Access Compliance Report
Public Rights-of-Way
(Curb Ramps)

Intersection ID: 5833 **Main Street:** GUM_BRANCH_RD **Cross Street:** KENTBERRY_DR **Location:** N

ADA ID: 061EF9660034 **Ramp Type:** BlendTrans1 **Initial Pass/Fail:** Fail **Overall Compliance:** No **Severity Score:** 8.75

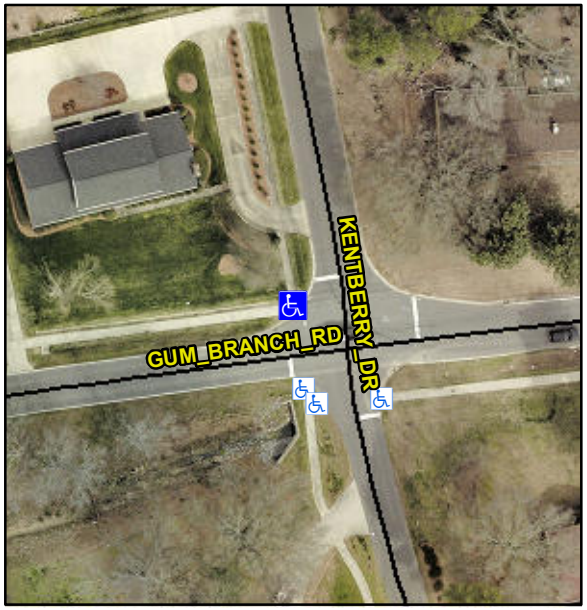
GTR GAP 1.0

Not Found, R304.5.1

Remove & Replace Curb Ramp With Two New Directional Ramps or Equivalent.
